KIA MOTORS

QUESTIONS AND ANSWERS FOR SAFETY RECALL CAMPAIGN (SC054)

**2002-2004 Sedona EX Power Seat Wire Harness Repair
November 21, 2005**

VOLUME 3	GROUP Campaign	MODEL Sedona
		NUMBER 054	DATE November 2005
TECHNICAL SERVICE BULLETIN			
SUBJECT: SAFETY CAMPAIGN: 2002-2004 SEDONA EX POWER SEAT WIRE HARNESS REPAIR

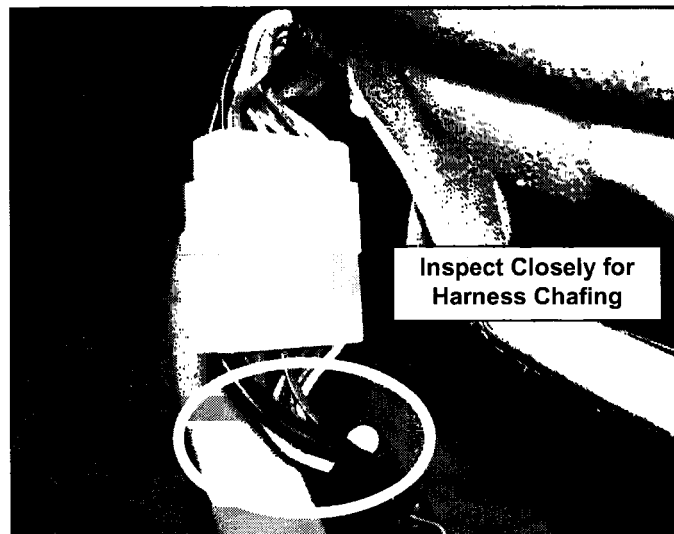
3. Closely inspect the power seat switch pigtail wire insulation for any damage from the sharp edges of the seat track. If damage is found to the insulation only, repair the wiring as required. If the wire core is affected, replace the seat switch assembly.

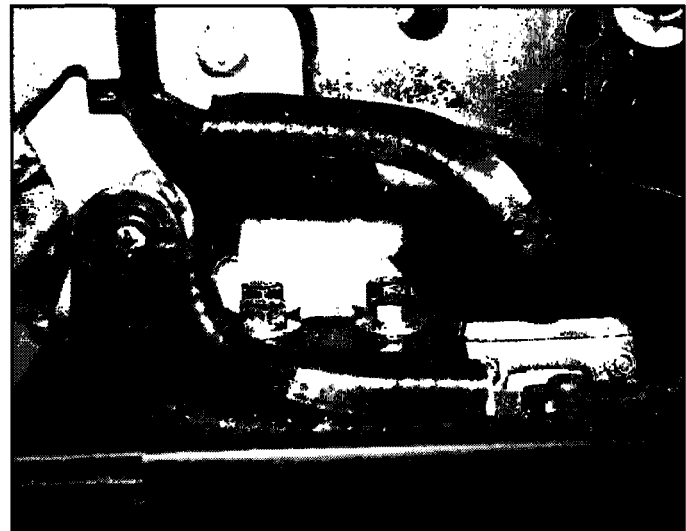
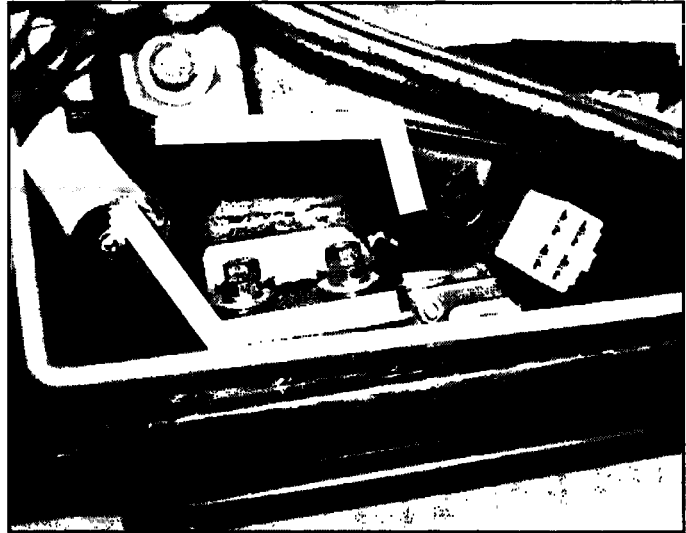
5. Install seaming welt over the sharp edges, as outlined in photo. Install the 75 ~ 80mm section of seaming welt on the upper seat track and the 60 ~ 80mm section of seaming welt onto the lower seat track.

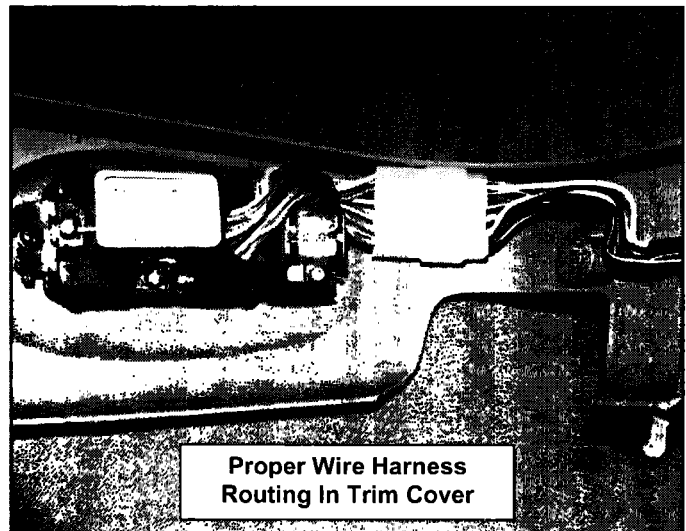
6. Re-assemble seat trim covers in the reverse order of removal. Reconnect lumbar switch connector. Be sure to route the wiring harness properly in the seat trim cover, as shown in photo.
